#### ROCKFORD BOARD OF EDUCATION INVITATION FOR BID ON SUPPLIES, MATERIALS, EQUIPMENT OR SERVICES FOR SCHOOL DISTRICT NO. 205 ROCKFORD, ILLINOIS

IFB No. 17-25 Rockford Public School District 205 School A, Zone 2

RE: **ADDENDUM NO. 2**

Rockford Public School District 205 School A, Zone 2 Cherry Valley, IL Cannon Project No. 005005.00 Cannon Design 225 N. Michigan Ave, Suite 1100 Chicago, Illinois 60601

1 ROOF FRAMING PLAN - AREA C

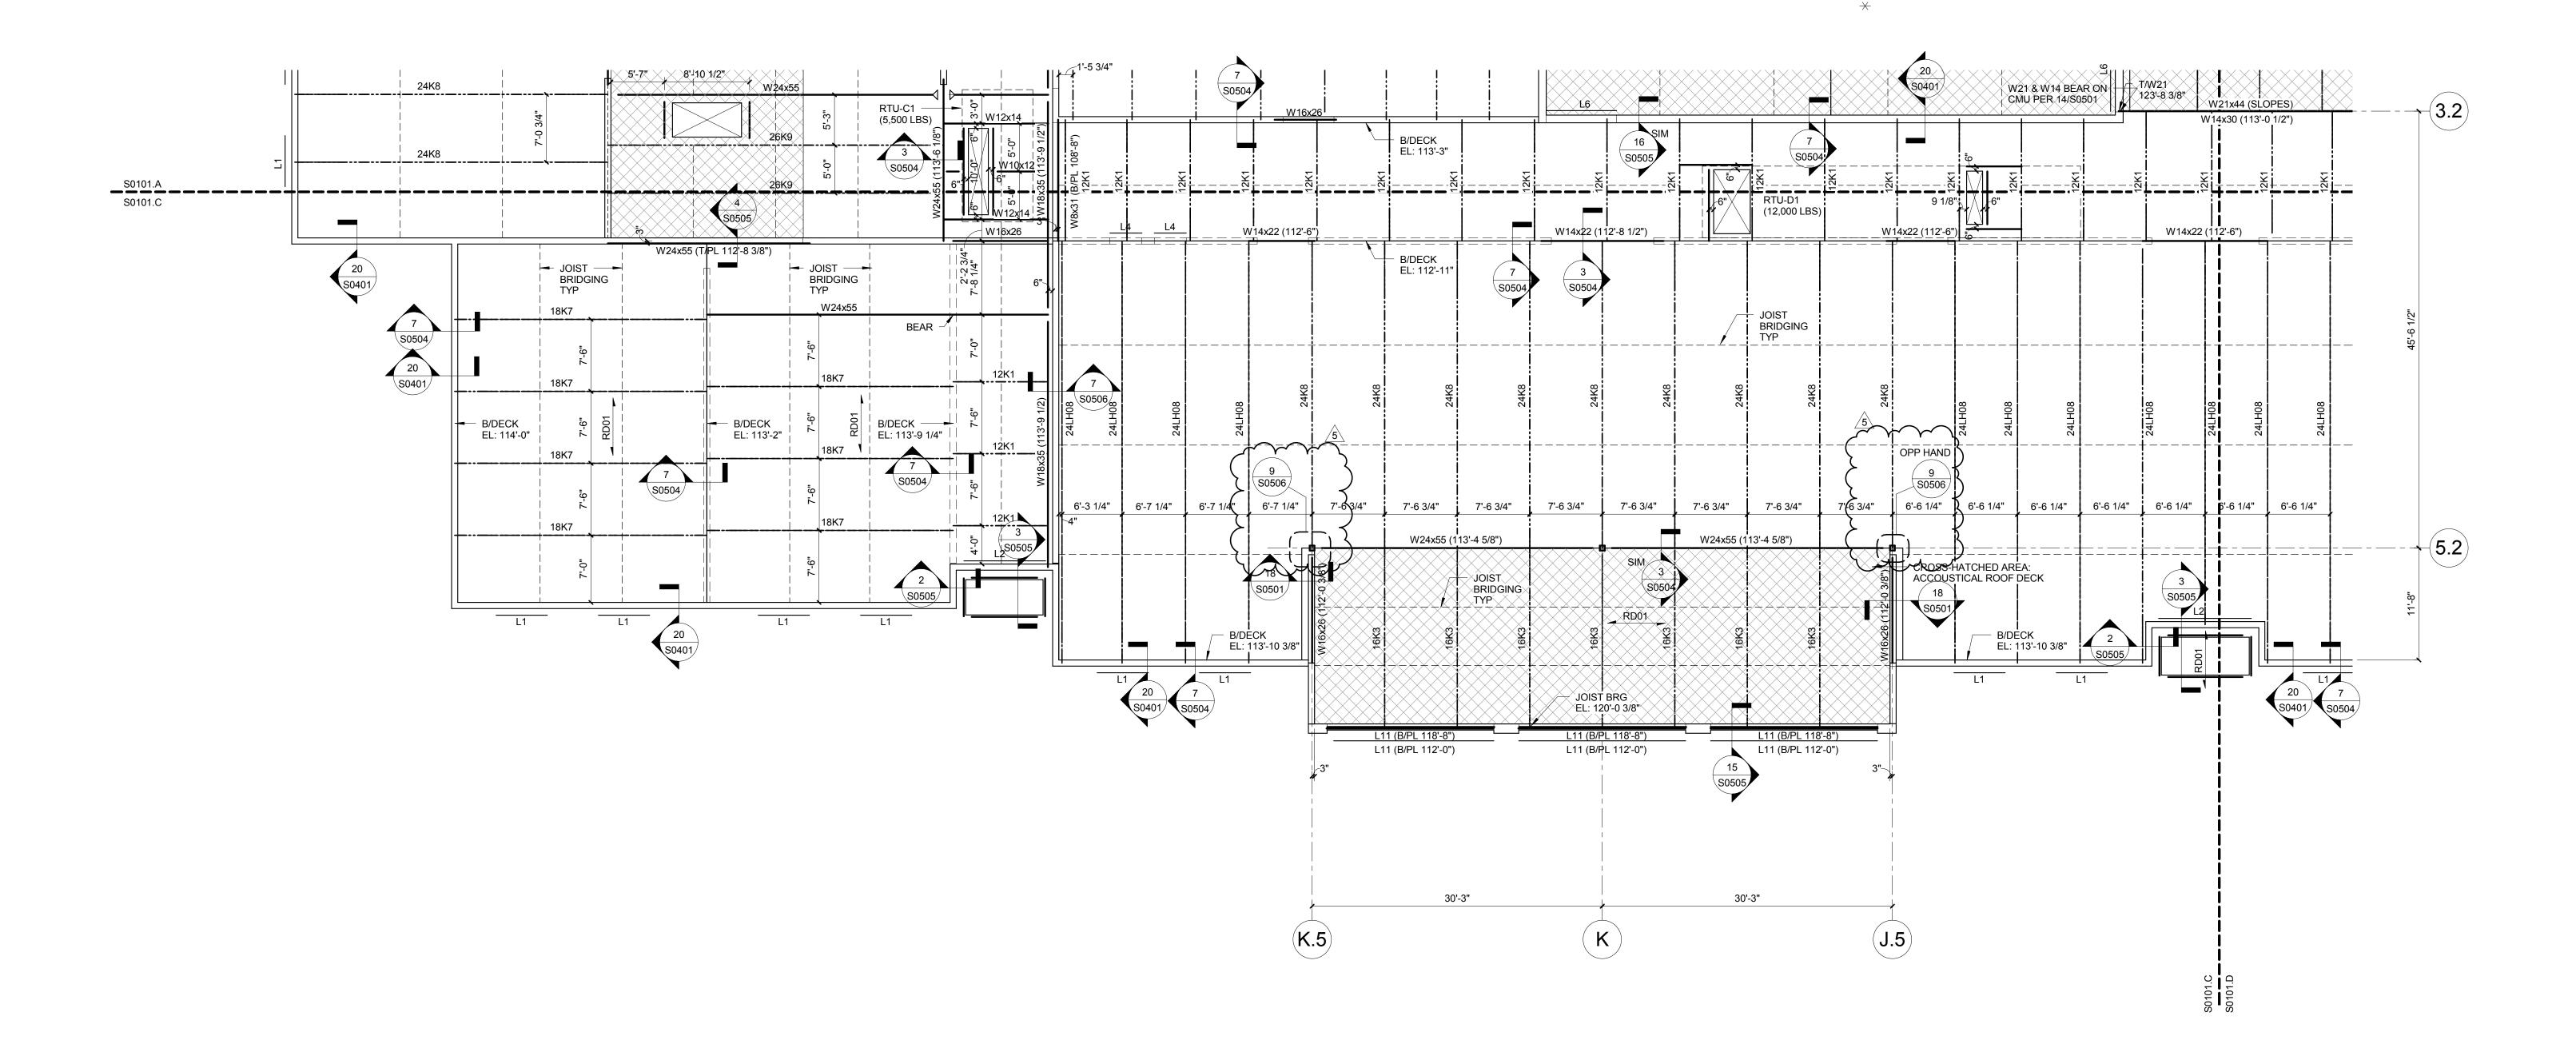
- A. Added/relocated shroud framing at small diameter roof penetrations
- B. Added sheet note

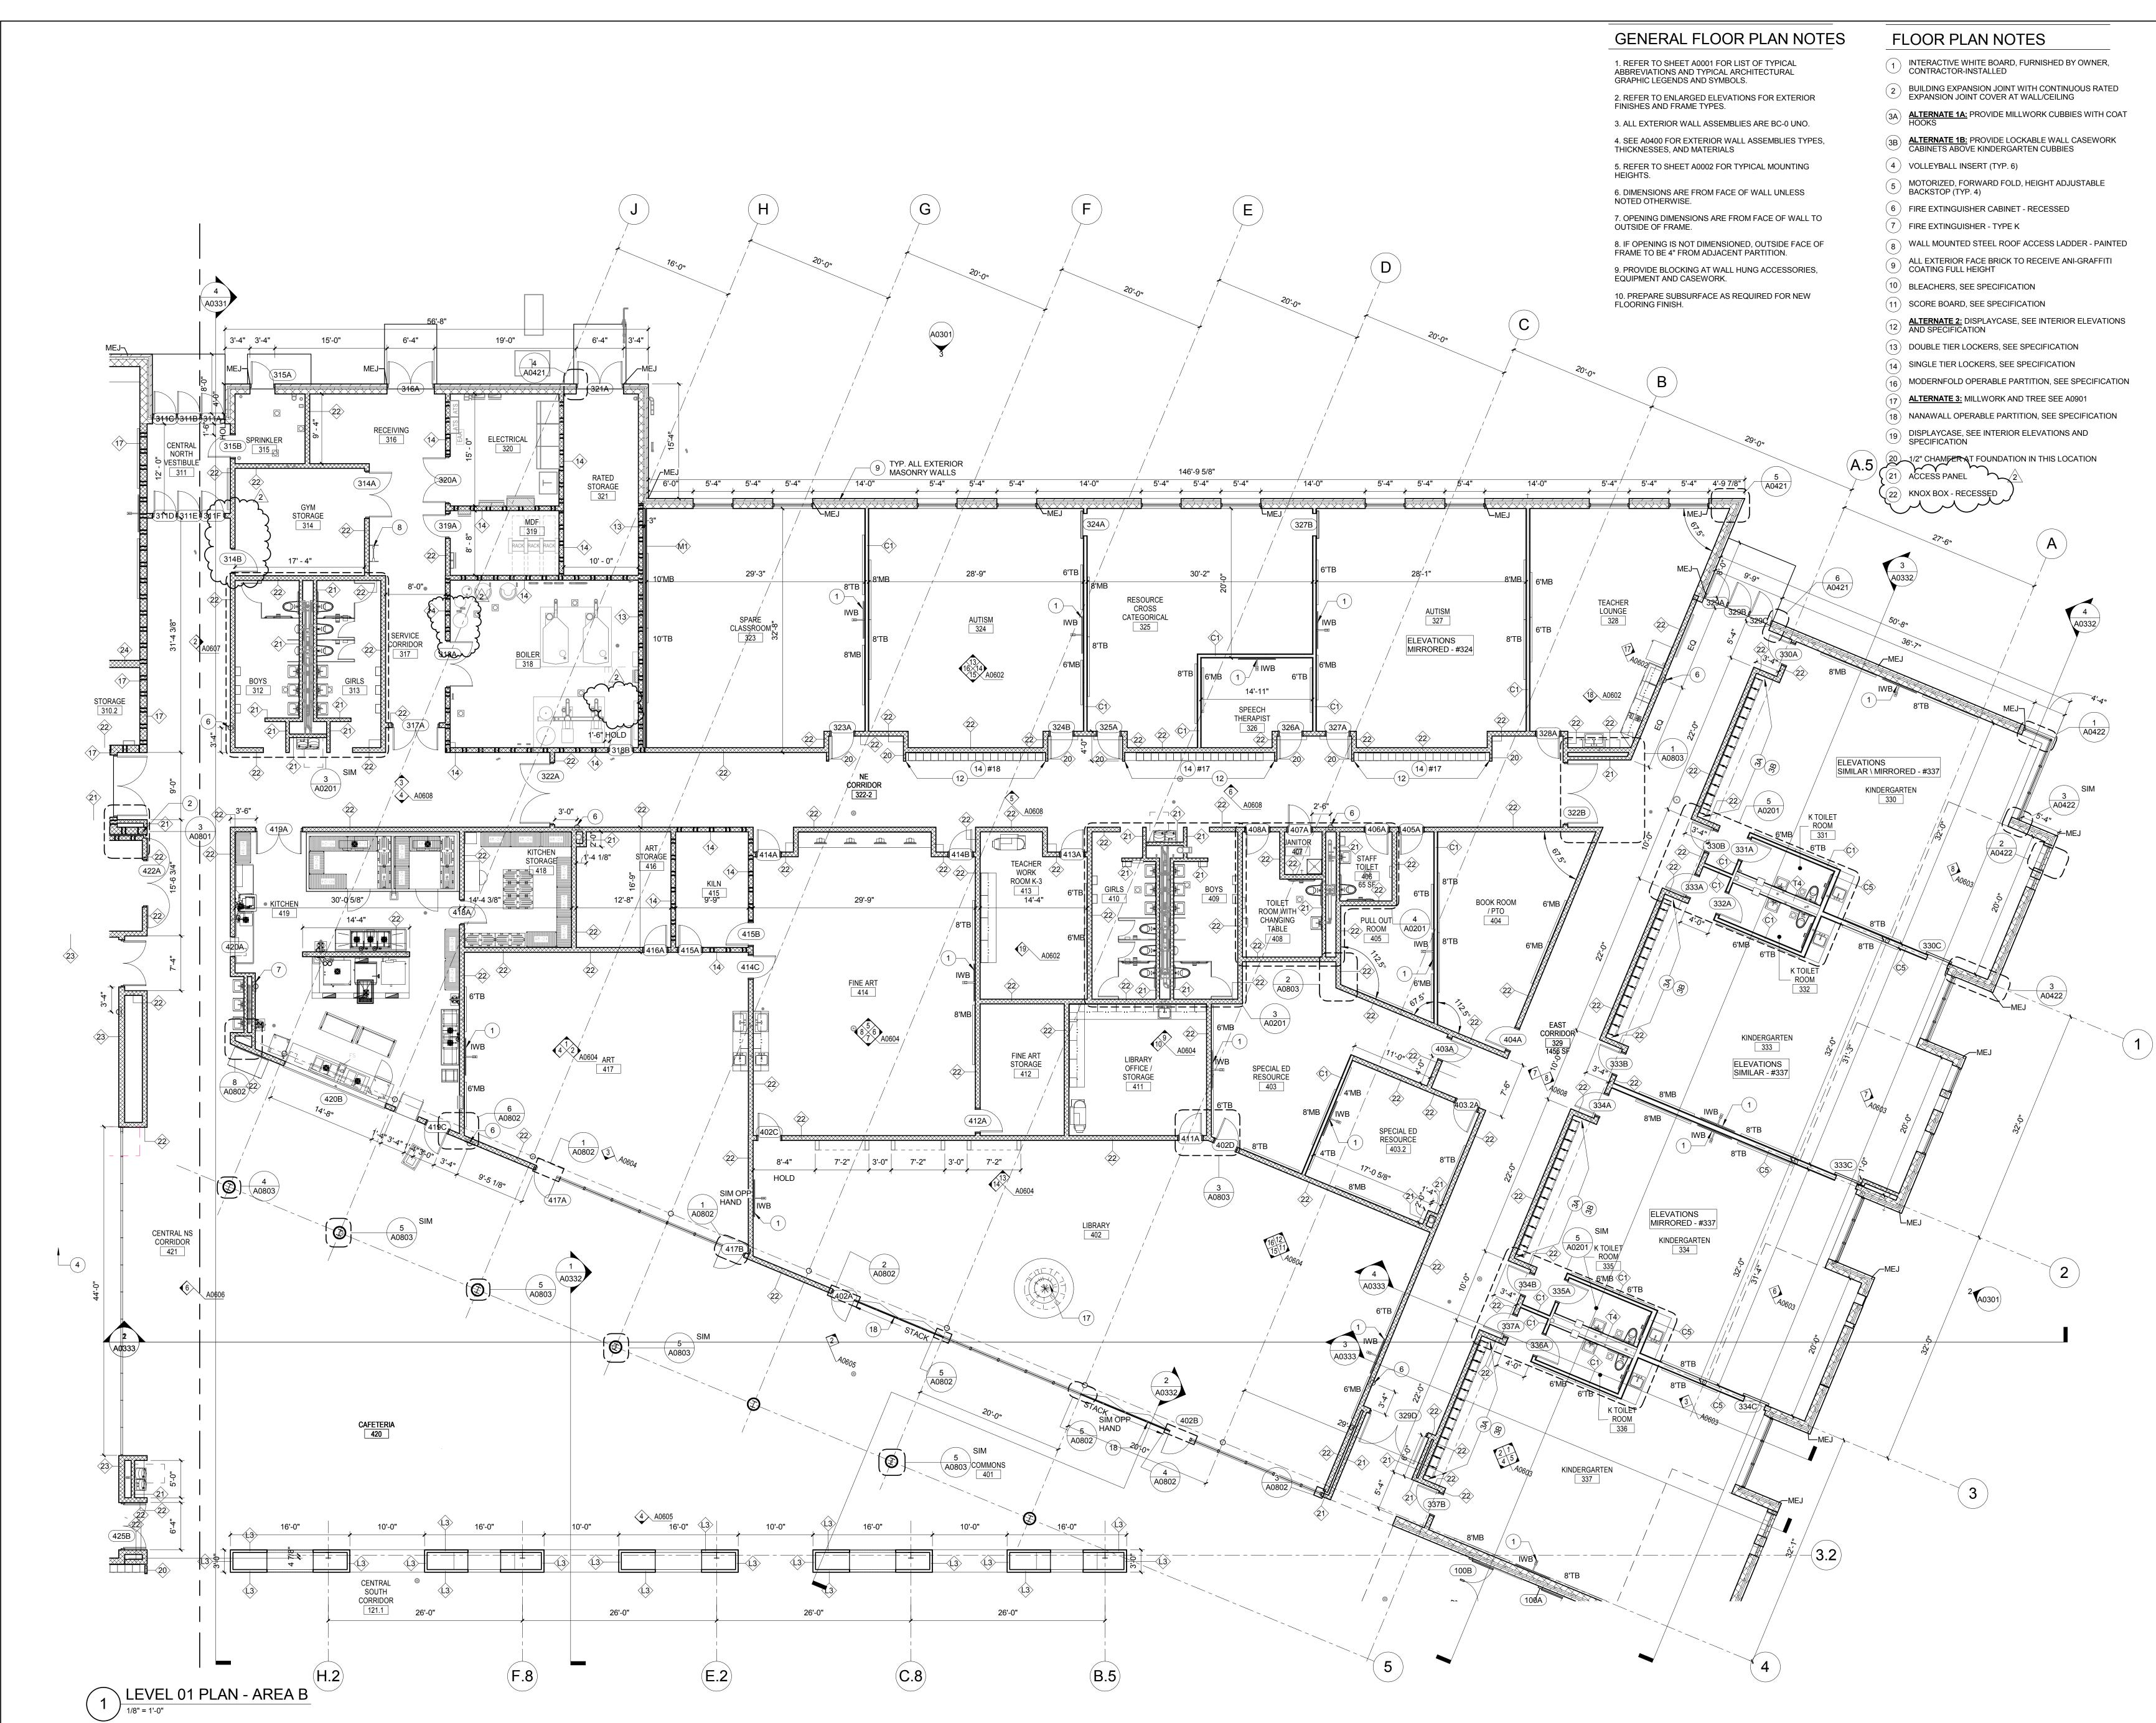
- 1. <u>G00 COVER SHEET</u>
  - B. Added Vicinity Map
- 2. <u>A0101 SERIES SHEETS:</u>
  - A. <u>Add key notes:</u>
    - 1. <u>21 ACCESS PANEL</u>
    - 2. KNOX BOX RECESSED

- A. Add Access Panel in Staff Toilet room 113, locate under hand dryer, add keynote 21 pointing at location.
- B. Add Recessed Knox Box at main entry, add keynote 22 pointing at location.
- 5. <u>A0102A ROOF PLAN AREA A</u>
  - A. At storm shelter roof, at two roof drain location, modify note to read: RD, SEE PLUMBING AND STRUCTURAL
  - B. At storm shelter roof, at two vents through roof locations, modify note to read: VENT THROUGH ROOF, IN PIPE CURB, SEE PLUMBING AND STRUCTURAL
  - C. At storm shelter roof, at exhaust fan location, modify note to read: EXHAUST FAN, ON ROOF CURB, SEE MECHANICAL AND STRUCTURAL
  - D. At storm shelter roof, at two relief hood locations, modify note to read: RELIEF HOOD, ON ROOF CURB, SEE MECHANICAL AND STRUCTURAL

1 LEVEL 02 HVAC PLAN - AREA B

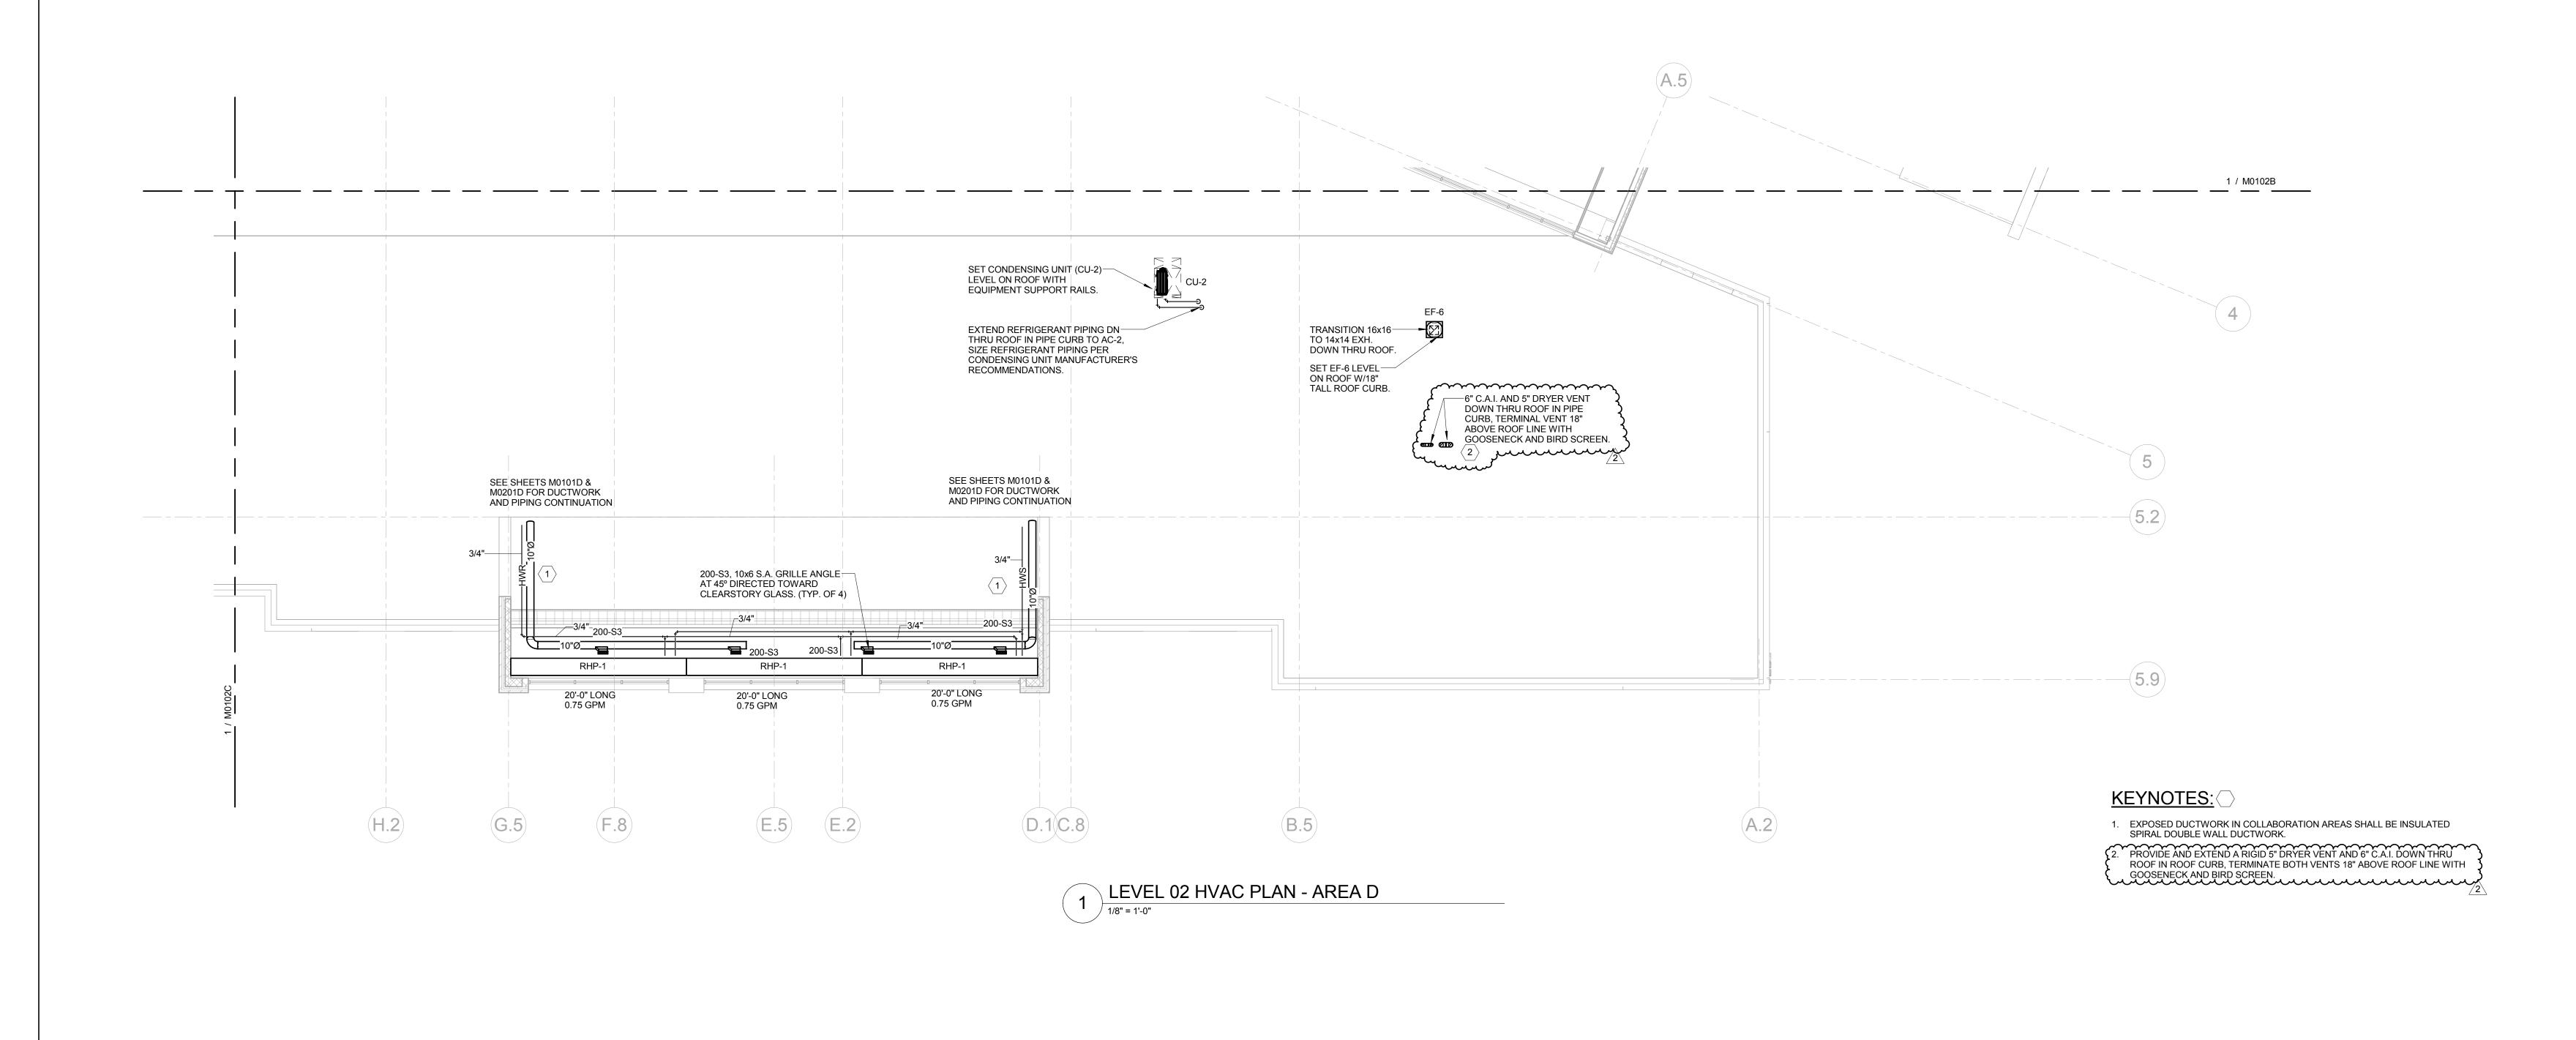
- A. Expansion loop for hot water piping was added to plans.
- B. Added keyed note #3
